Our ref: STH09/01095/17
Contact: Andrew Lissenden
Your ref: MP09_0131 MOD 1

TALLAWARRA LANDS MIXED USE DEVELOPMENT (MP09_0131 MOD 1) – RESPONSE TO SUBMISSIONS

- *Traffic Impact Assessment/Modelling:* RMS from reviewing the updated *Traffic Impact Assessment* (TIA) prepared by Cardno (Job Ref: 8201714202, Version 04, dated 18 April 2019) provides the following comments:

Figure 5-7 Northern Interchange Performance Locations

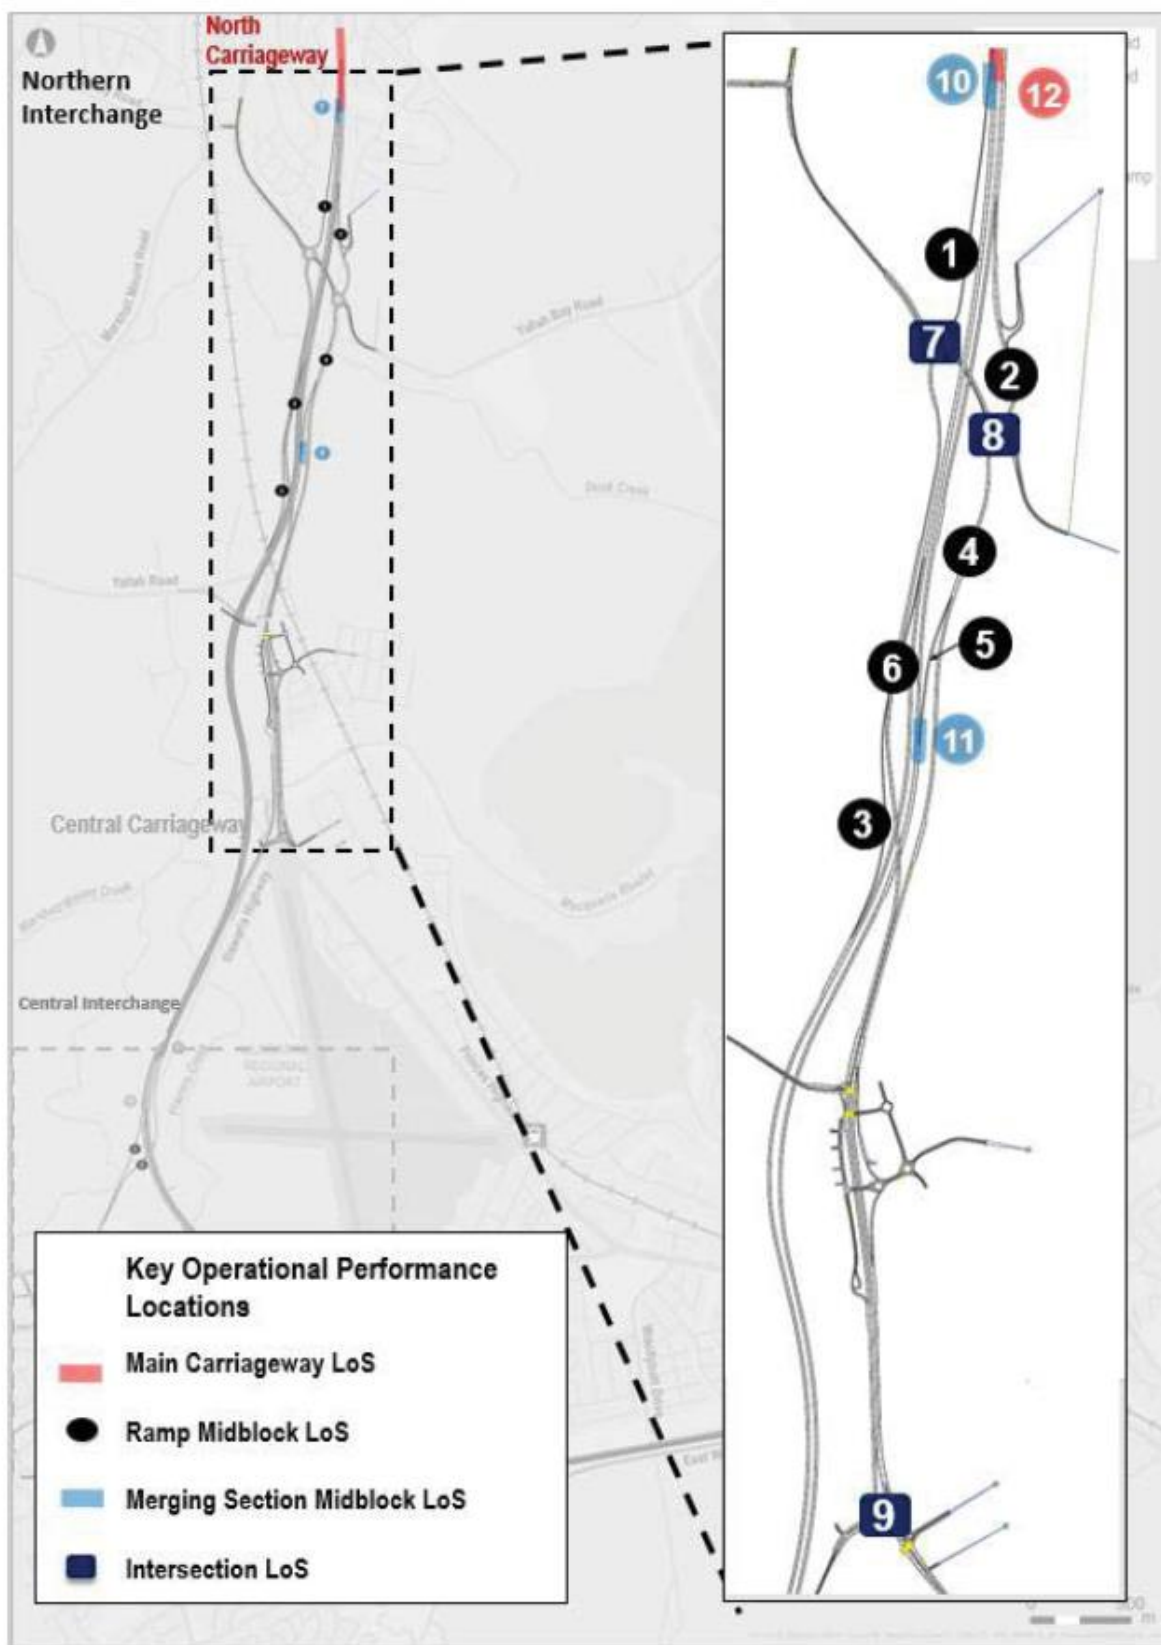
This is 'C' in the updated Traffic Report submitted which is a change from current.

This is 'D' in the updated Traffic Report submitted which is concern for RMS.

RMS assumed this was a signalised roundabout in 2041 and as a result RMS has 'B' not 'D' as contained in the updated Traffic Report submitted.
